ADA Curb Ramp New Construction Inspection Form (Parallel)

Shadybrook

24952.54

Yorkshire

PARALLEL RAMP (PL)

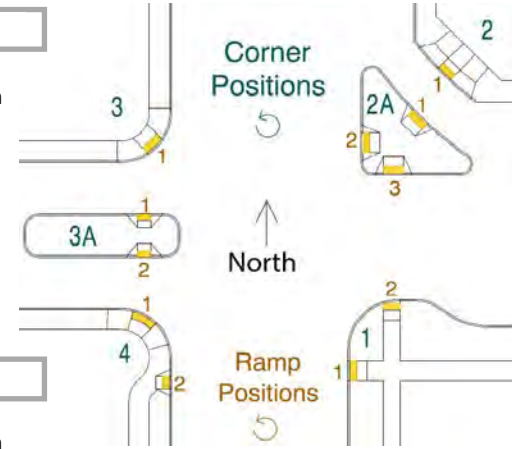
2.9 $\leq 2.0\%$ ☐ $> 2.0\%$ ☒

$\leq 2.0\%$ ☐ $> 2.0\%$ ☒

N Y ☐ N ☒

☐ 14.08 $\leq 8.3\%$ ☐ $> 8.3\%$ ☒

6 $\leq |5.0\%|$ ☐ $> |5.0\%|$ ☒

N Y ☐ N ☒

2.8 $\leq 2.0\%$ ☐ $> 2.0\%$ ☒

3.1 $\leq 2.0\%$ ☐ $> 2.0\%$ ☒

3.8 $\geq 4.0'$ ☐ $< 4.0'$ ☒

2.9 $\leq 2.0\%$ ☐ $> 2.0\%$ ☒

3.8 $\geq 4.0'$ ☐ $< 4.0'$ ☐

No Td.
